Project	IEEE 802.16 Broadband Wireless Access Working Group < http://ieee802.org/16 >	
Title	Merging the figure of CXCC sub-channels	
Date Submitted	2007-11-04	
Source(s)	Wu Xuyong Huawei, Huawei Industry Base, Bantian, Longgang, Shenzhen, China 518129	Voice: +86-755-28976776 Fax: wuxuyong@huawei.com ,
Re:	IEEE 802.16-07/050: IEEE 802.16 Working Group Letter Ballot #29: Announcement (2007-10-05)	
Abstract	Merging CXCC sub-channels 1-4 and CSI sub-channel into one figure	
Purpose	To consolidate the 16h draft.	
Notice	This document has been prepared to assist IEEE 802.16. It is offered as a basis for discussion and is not binding on the contributing individual(s) or organization(s). The material in this document is subject to change in form and content after further study. The contributor(s) reserve(s) the right to add, amend or withdraw material contained herein.	
Release	The contributor grants a free, irrevocable license to the IEEE to incorporate material contained in this contribution, and any modifications thereof, in the creation of an IEEE Standards publication; to copyright in the IEEE's name any IEEE Standards publication even though it may include portions of this contribut

Figure h33—CXCC sub-channels 1-4 allocation

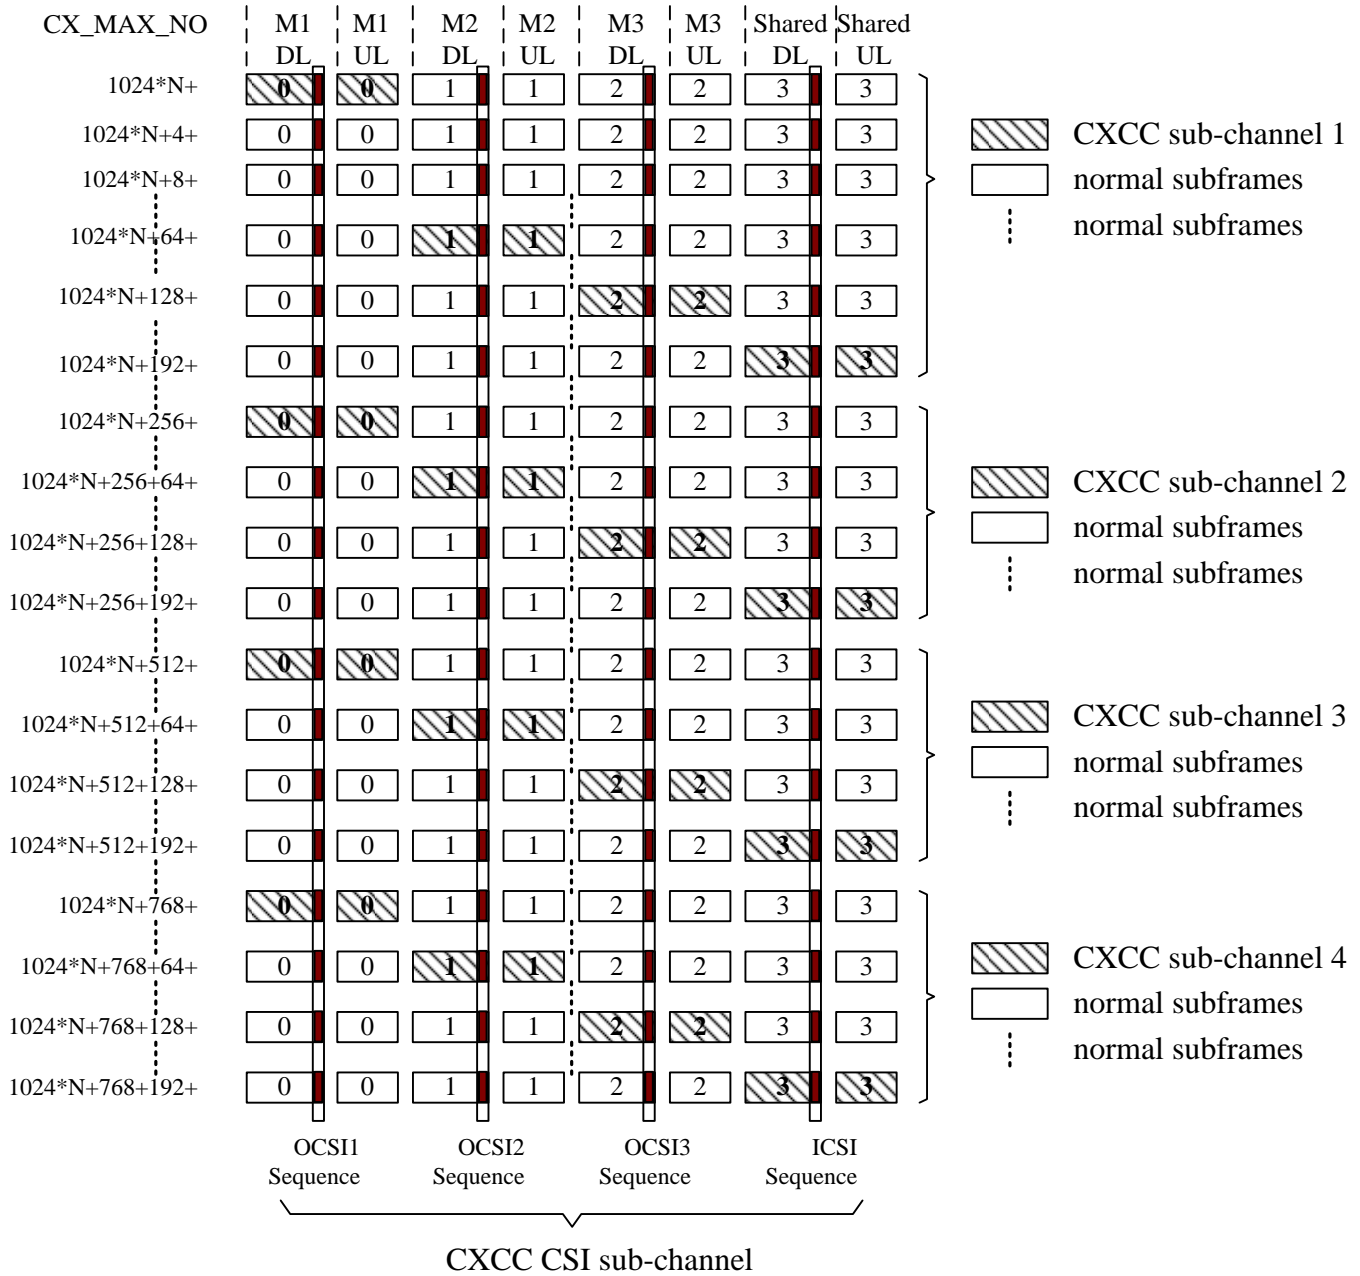
- 1) The basic allocation information of all the sub-channels needs to come together into 15.3.1.1;*
- 2) The 2 figures should merge into one in case that we simplify and fix the parameter CSI_Cycle to 1 ;*
- 3) The usage of different portion of CSI sub-channel should be provided within 15.3.1.2.5*

- The CXCC four sub-channels are scheduled in consecutive order.
- The duration of a CXCC sub-channel is:
 - o $1024 / 4 = 256$ MAC frames (1280 ms)
 - o The CXCC allocations appear in average every $256/8=32$ MAC Frames (~~160ms~~320ms).

- The CXCC allocations during any one of CXCC sub-channel 1-4 are:
 - o Master allocation 1-sub frame DL: $CX_MAC_NO \bmod 256 = 0$
 - ~~o Master 1 sub frame UL: $CX_MAC_NO \bmod 256 = 32$~~

- o Master allocation 2-sub frame DL: $CX_MAC_NO \bmod 256 = 64+1$
 - ~~o Master 2 sub frame UL: $CX_MAC_NO \bmod 256 = 96+1$~~
 - o Master allocation 3-sub frame DL: $CX_MAC_NO \bmod 256 = 128+2$

- ~~o Master 3 sub frame UL: $CX_MAC_NO \bmod 256 = 160+2$~~
 - o Shared allocation sub frame DL: $CX_MAC_NO \bmod 256 = 192+3$
 - ~~o Shared sub frame UL: $CX_MAC_NO \bmod 256 = 224+3$.~~

- The CXCC allocations during CSI sub-channel is:
 - o OCSI for the system with Master allocation 1: $CX_MAC_NO \bmod 4 = 0$
 - o OCSI for the system with Master allocation 2: $CX_MAC_NO \bmod 4 = 1$

- o OCSI for the system with Master allocation 3: $CX_MAC_NO \bmod 4 = 2$
 - o ICSI for the initialization system: $CX_MAC_NO \bmod 4 = 3$

Figure h34 — CSI and CSI sequences allocation as a CXCC sub-channel

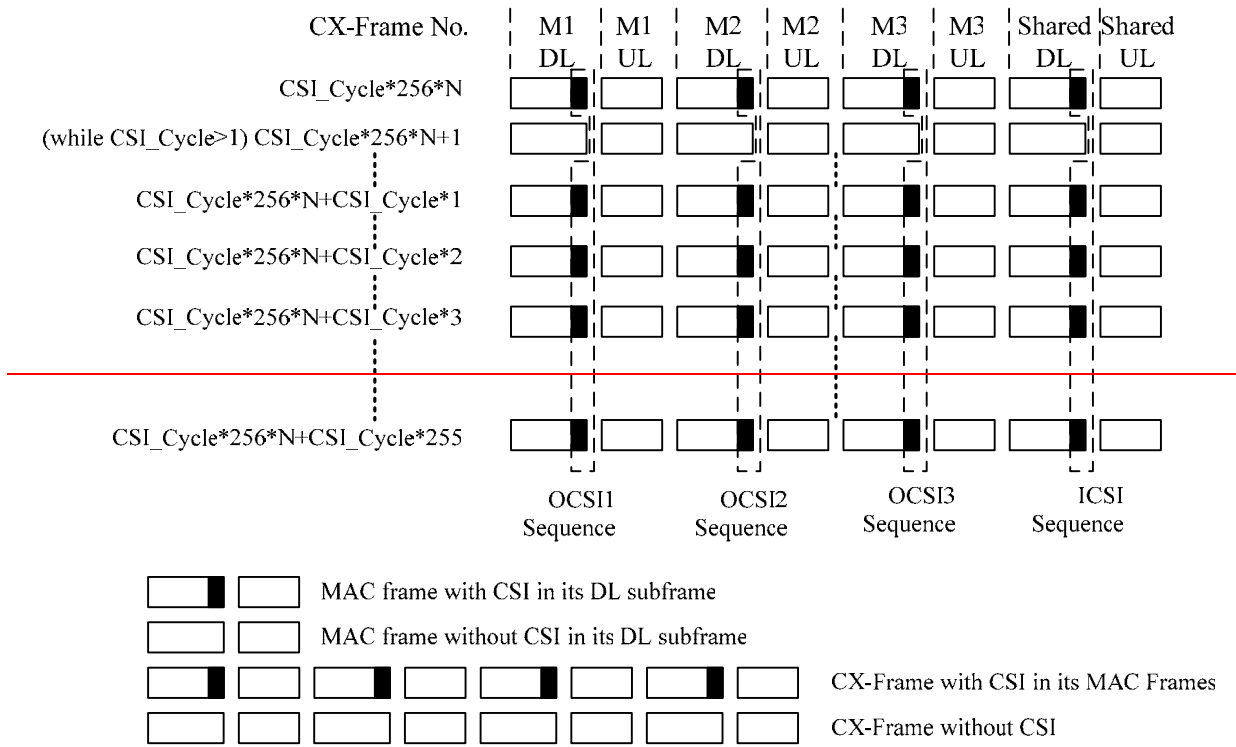
The CSI allocations will shall be allocated transmitted, if supported, in the last 100us of each DL subframe within CX-Frame. of the Master sub-frame w allocations. No other transmissions are allowed during these intervals. CSI sub-channel is used for interference identification and basic connectivity creation within interference neighborhood. The ICSI shall be allocated within the shared frame, which is used for initialization WirelessMAN-CX systems. And the OCSI shall be allocated for each WirelessMAN-CX system to the Master allocation, wich is used for operating WirelessMAN-CX systems.

o Master 1 sub-frame DL: CX_MAC_NO mod CSI_cycle*4 = 0

- o Master 2 sub frame DL: $CX_MAC_NO \bmod CSI_cycle*4 = 1$
- o Master 3 sub frame DL: $CX_MAC_NO \bmod CSI_cycle*4 = 2$
- o Shared sub frame DL: $CX_MAC_NO \bmod CSI_cycle*4 = 3$
